BLOCK 37

DESIGN REVIEW

CASE # LU 14-117884 DZM

DESIGN REVIEW AUG. 21, 2014

GROUND FLOOR PLAN

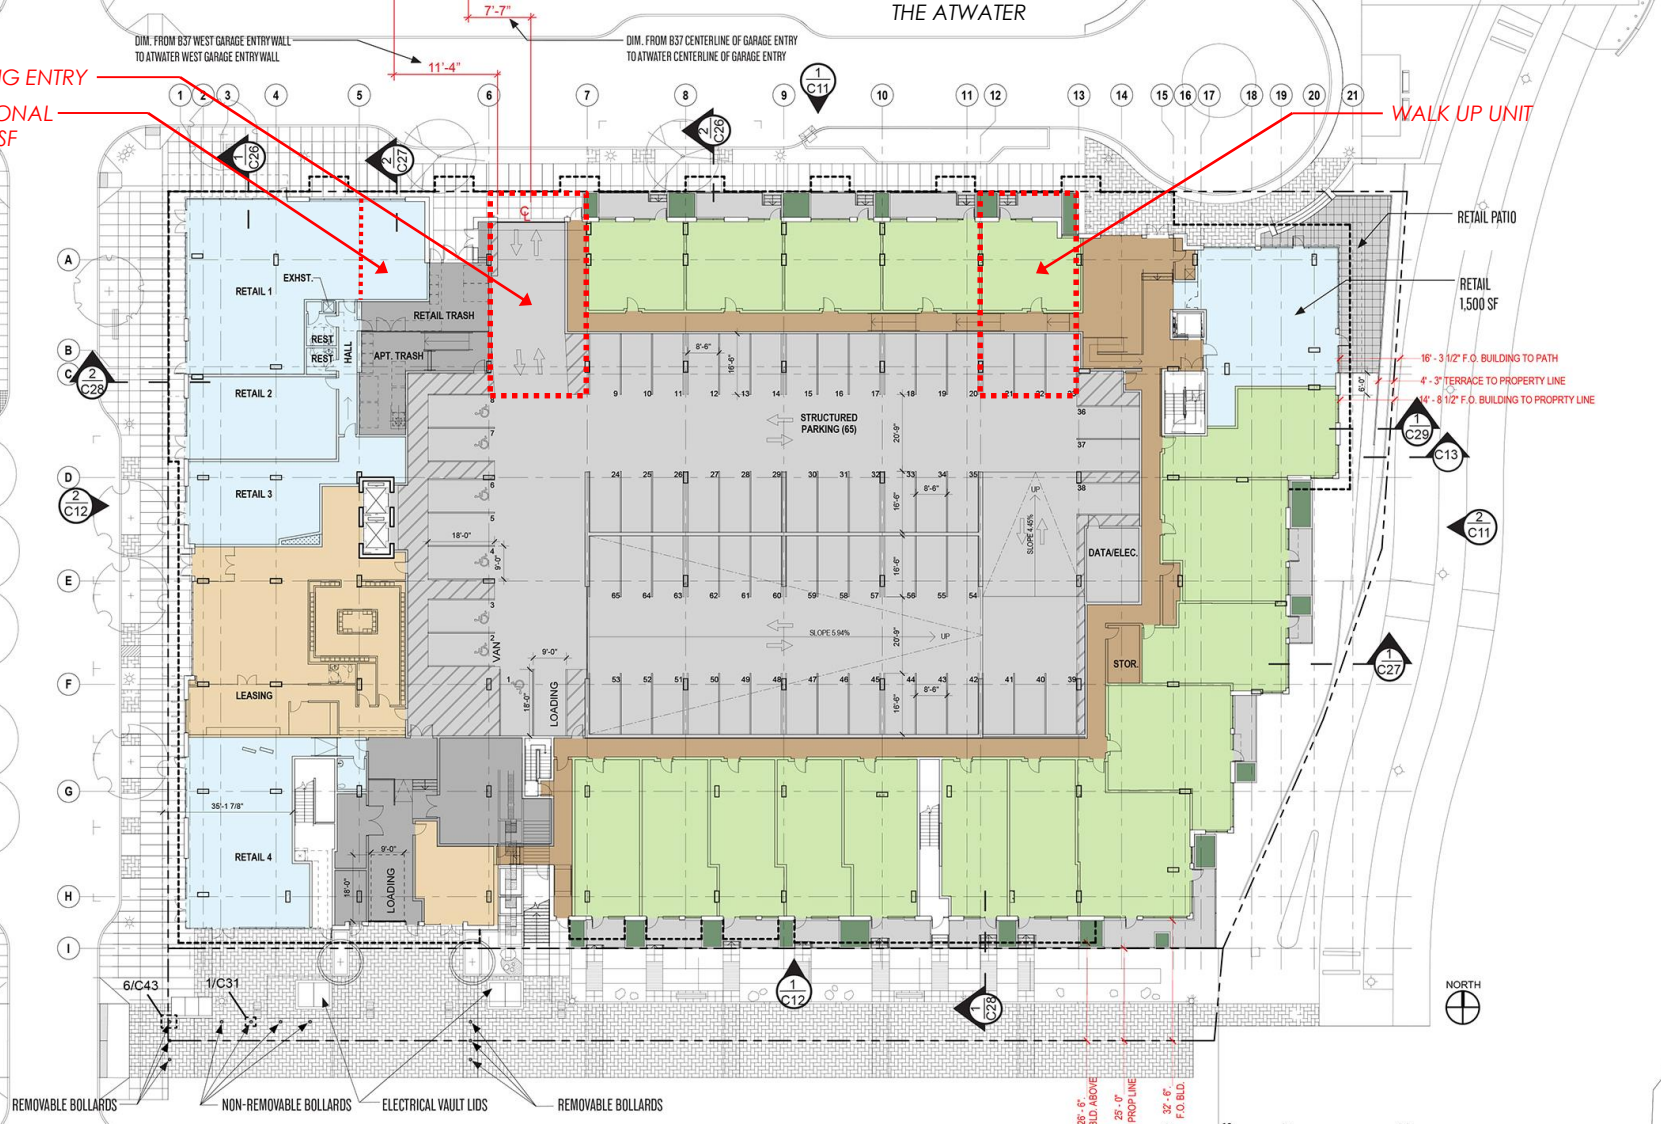
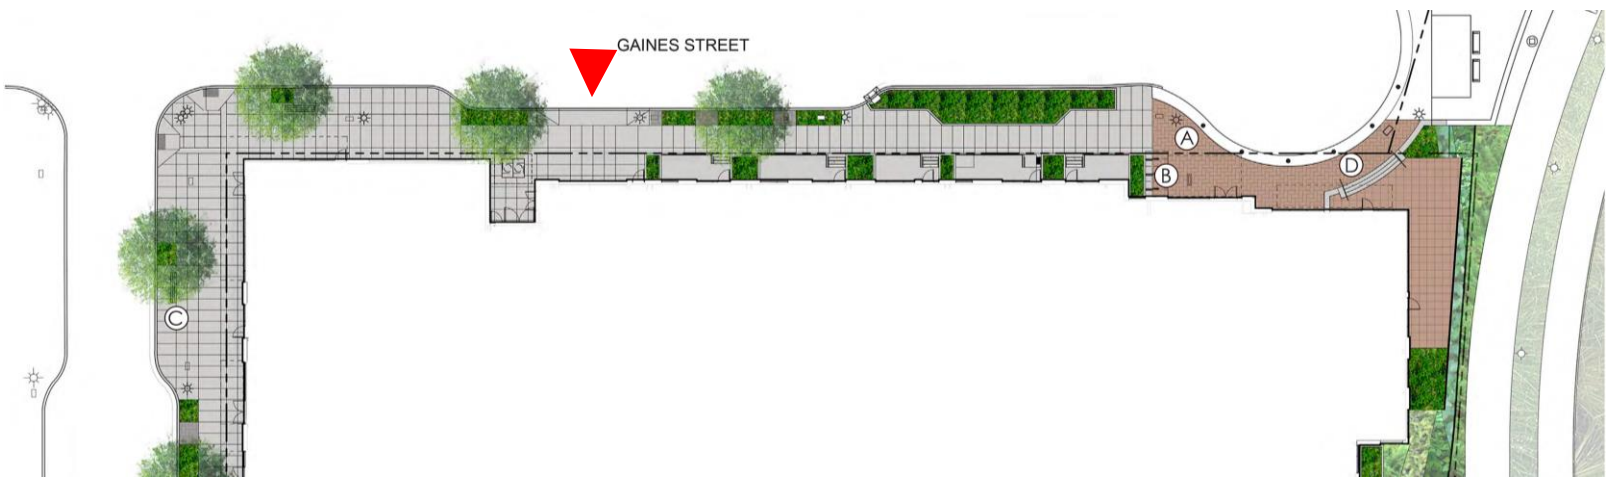
GARAGE ENTRY

PARKING ENTRY
ADDITIONAL
RETAIL SF

{PRESENTED JULY 10, 2014}

REVISED AUG. 21, 2014}

NORTH ELEVATION (Gaines St.)

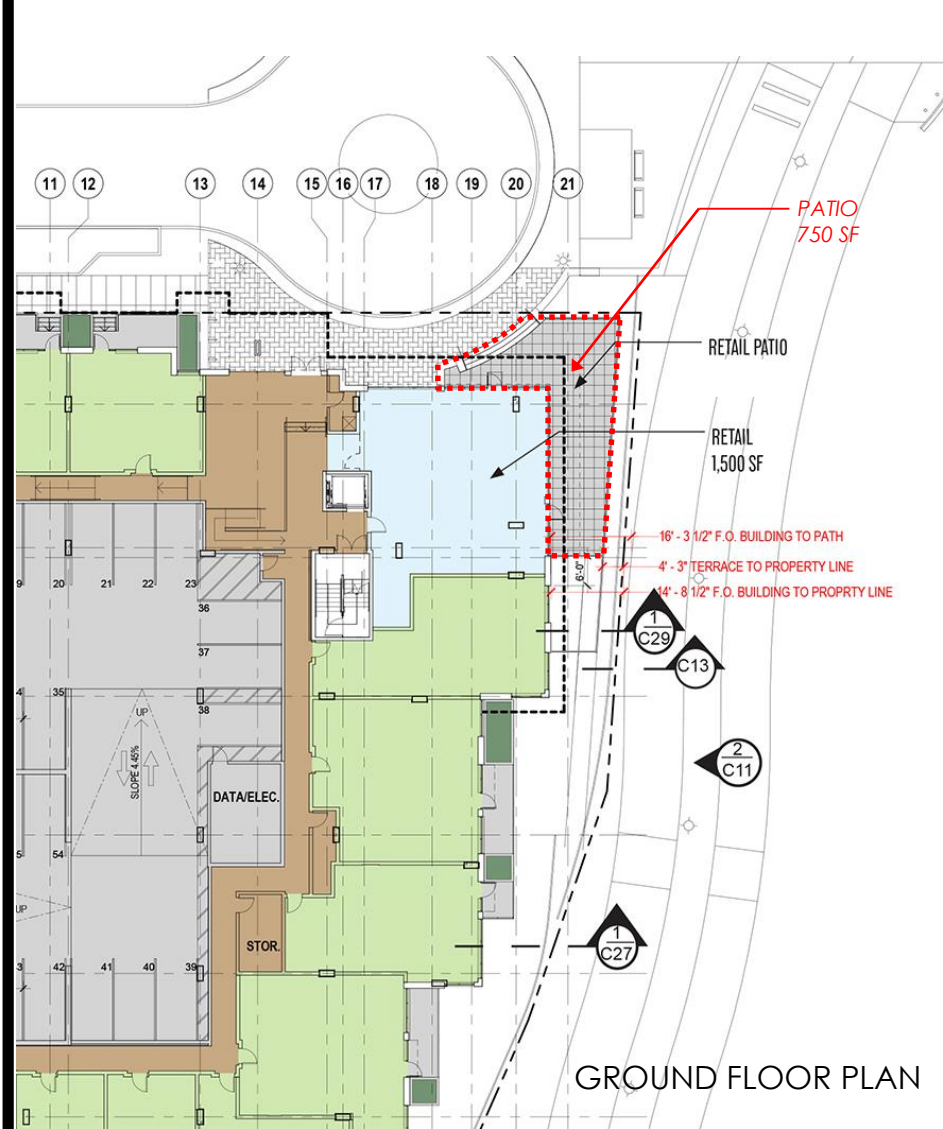
BALCONIES

(NORTH FAÇADE)

{PRESENTED JULY 10, 2014}

{REVISED AUG 21, 2014}

GREENWAY SECTION A-A

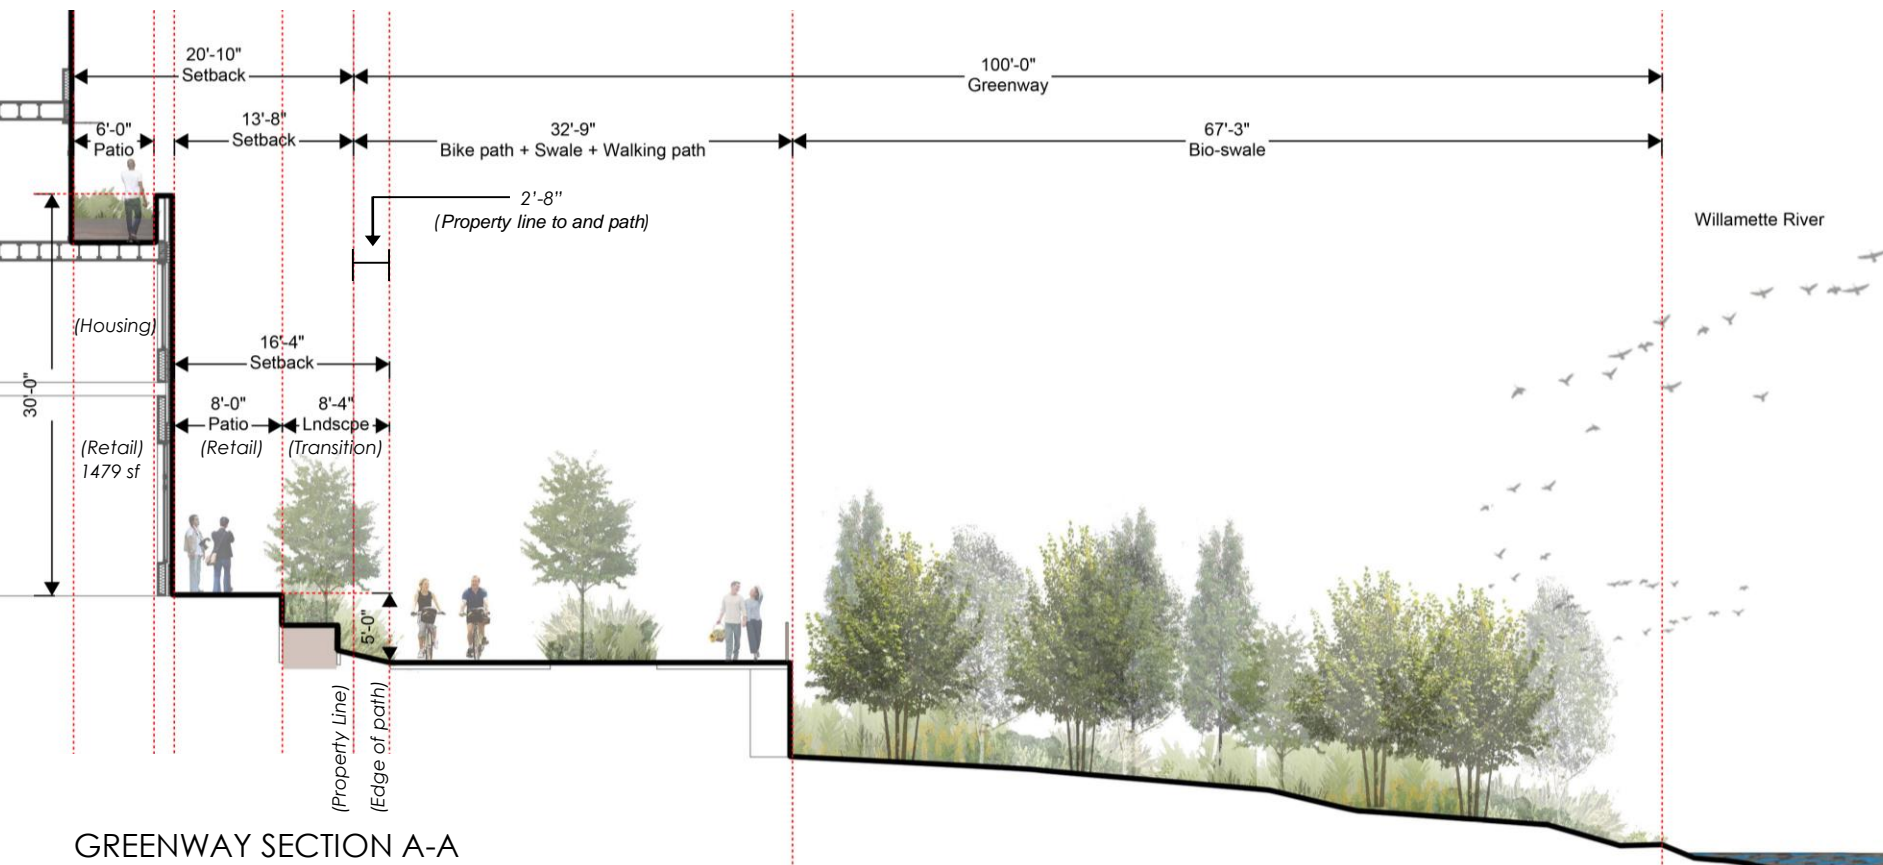
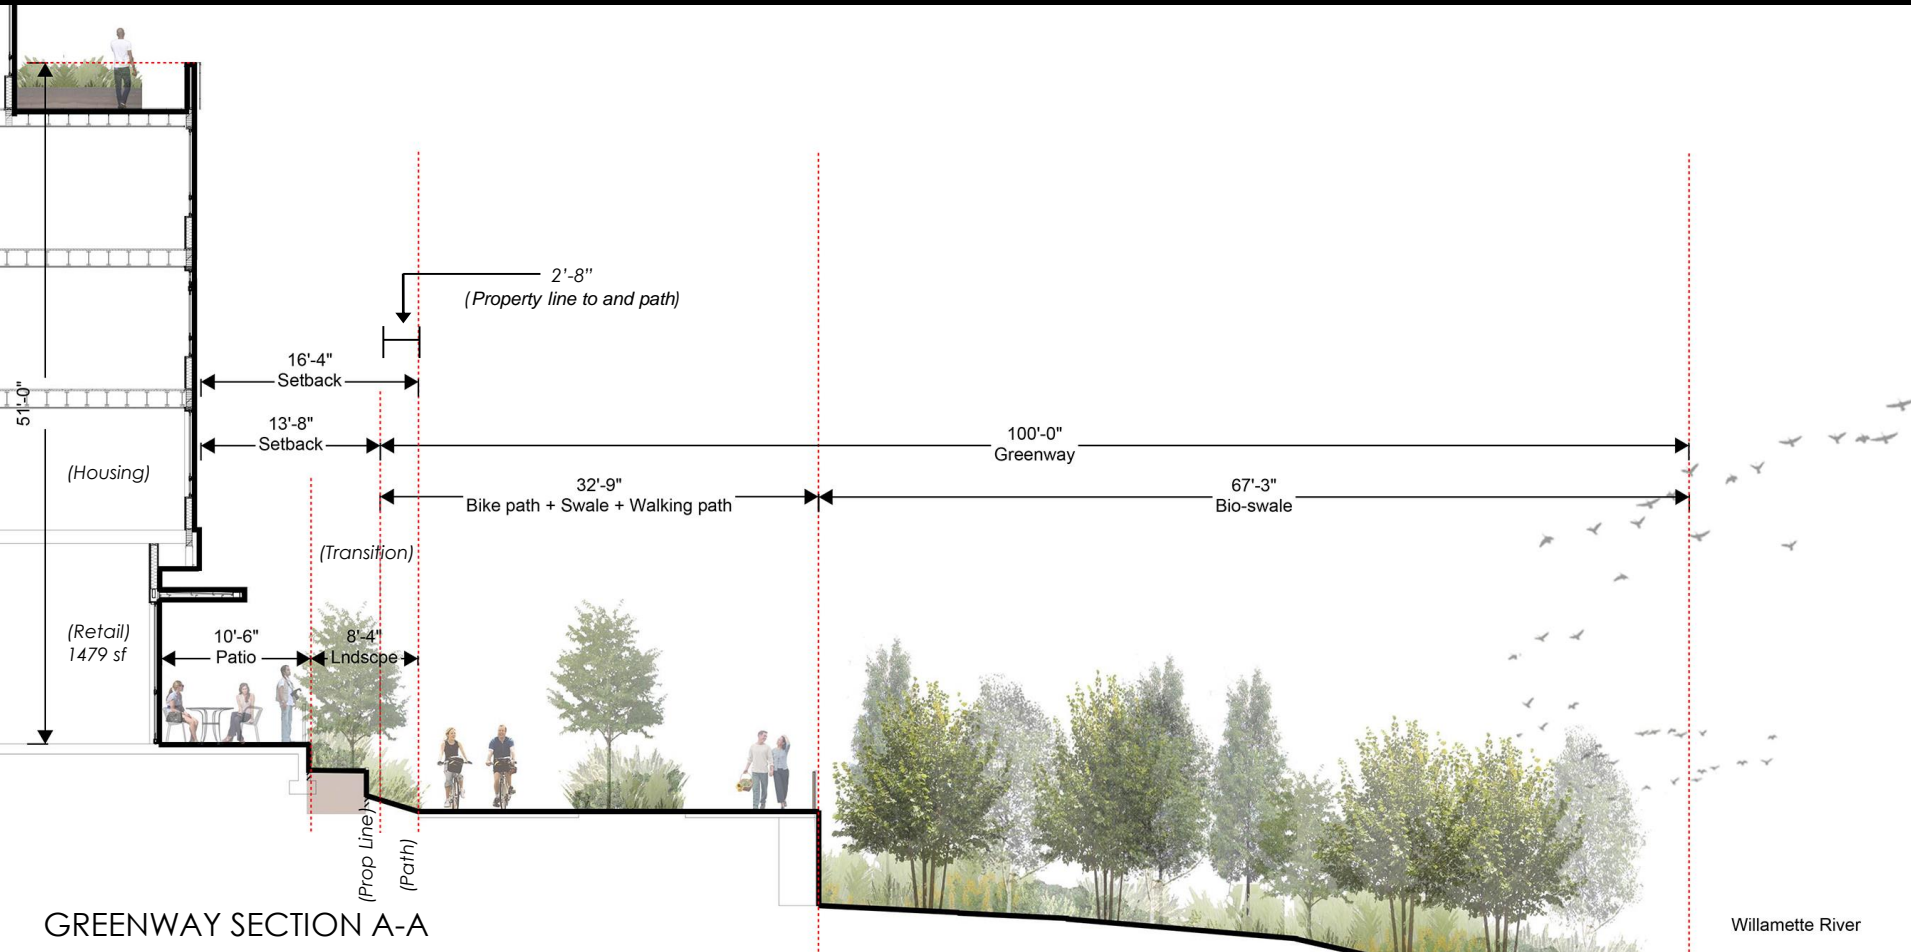
GREENWAY PATIO

{PRESENTED JULY 10, 2014}

{REVISED AUG. 21, 2014}

EAST ELEVATION (Greenway)

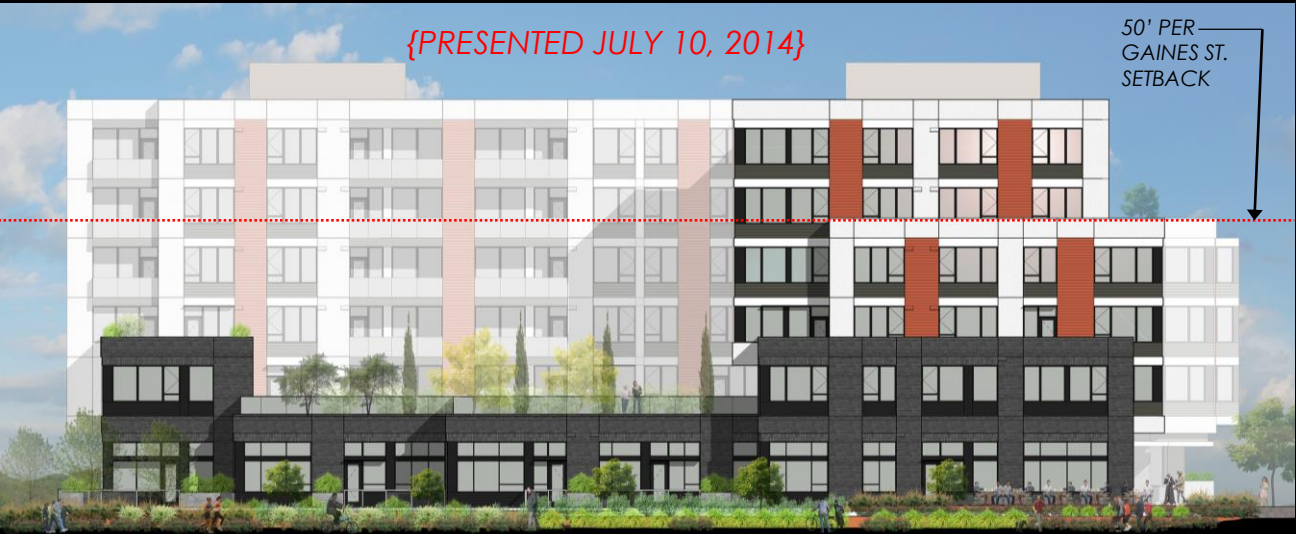
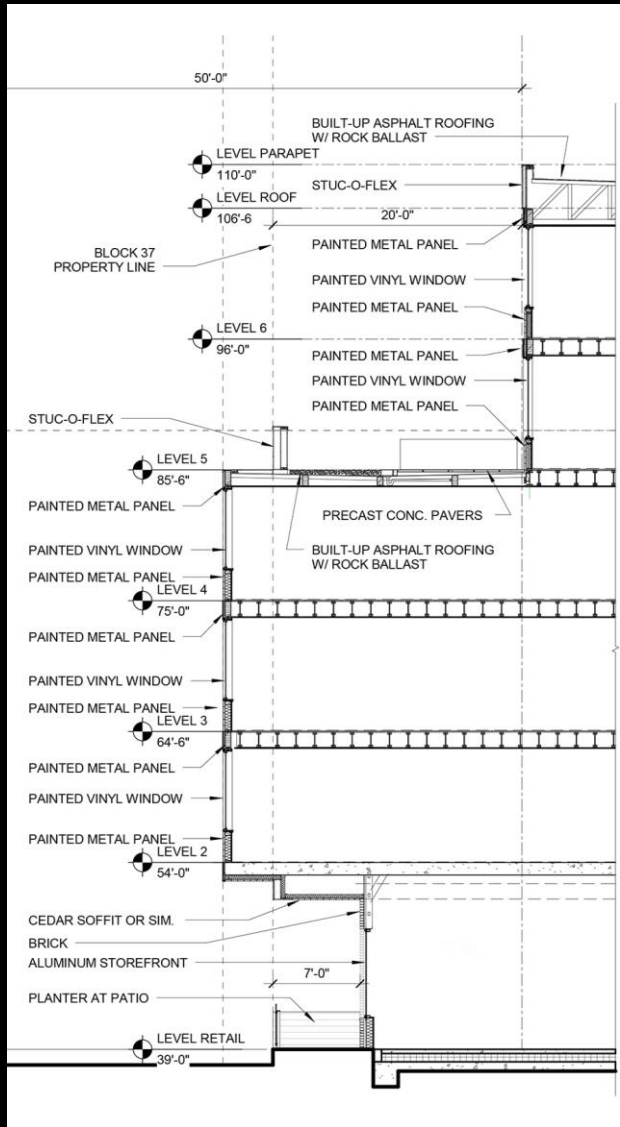
COHERENCY

(NORTHEAST CORNER)

{PRESENTED JULY 10, 2014}

{REVISED AUG. 21, 2014}

SOUTH ELEVATION (Lane St.)

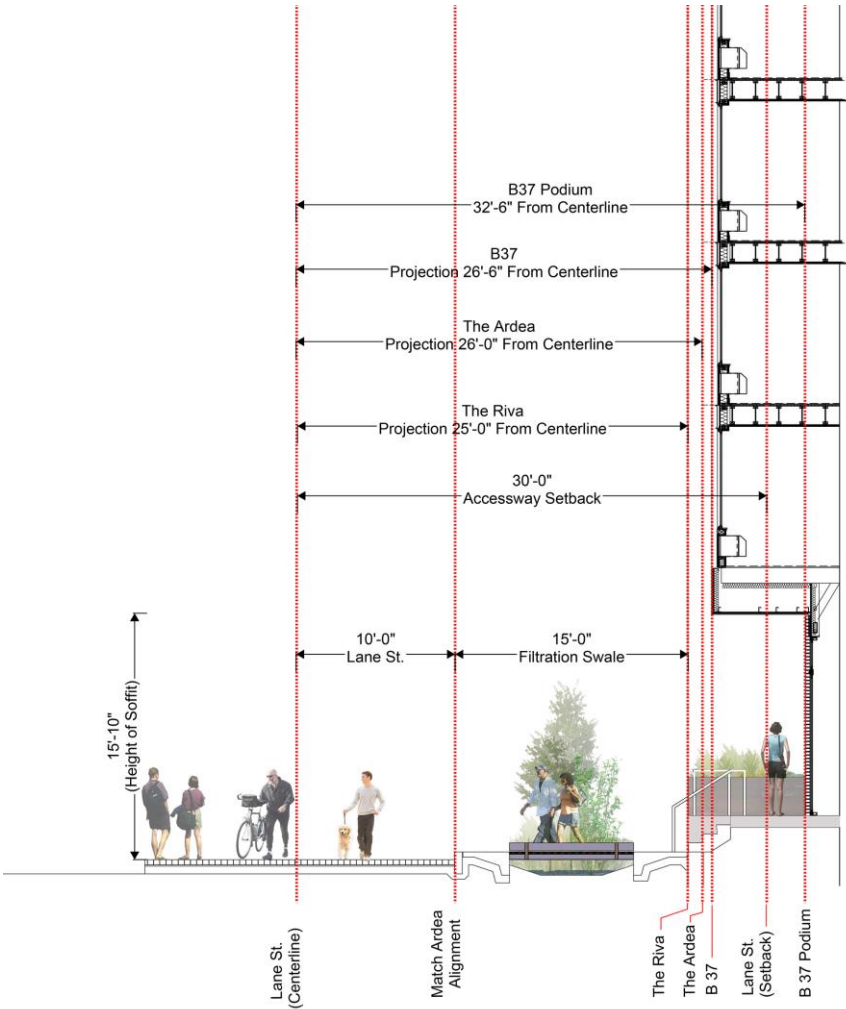
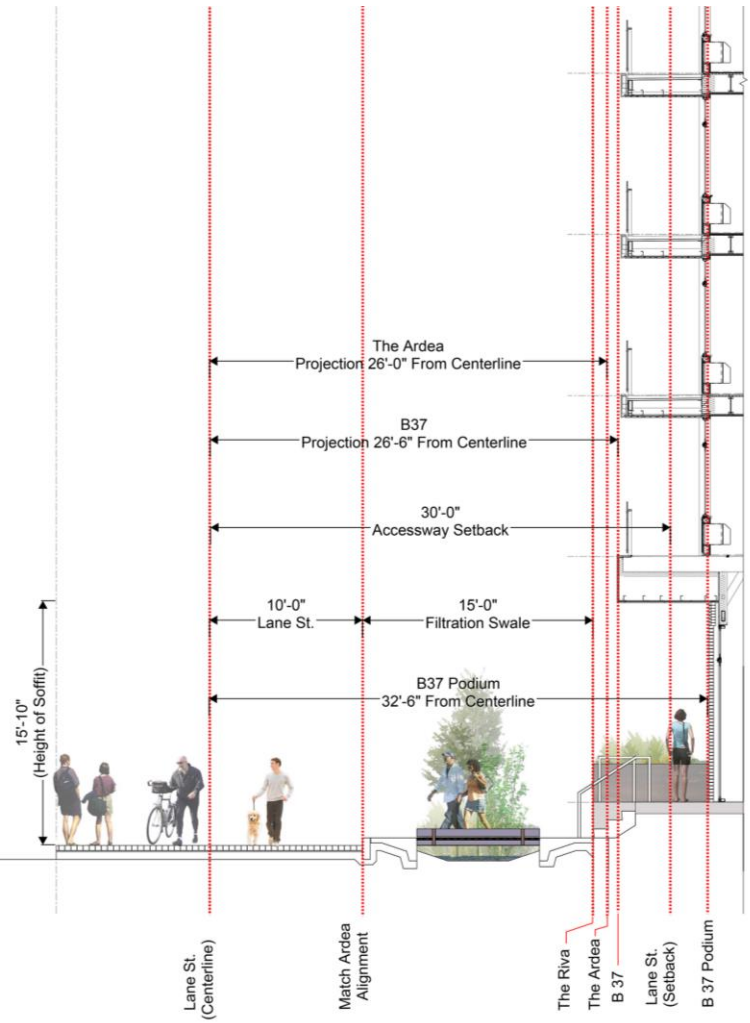
BALCONIES

(SOUTH FAÇADE)

{PRESENTED JULY 10, 2014}

{REVISED AUG. 21, 2014}
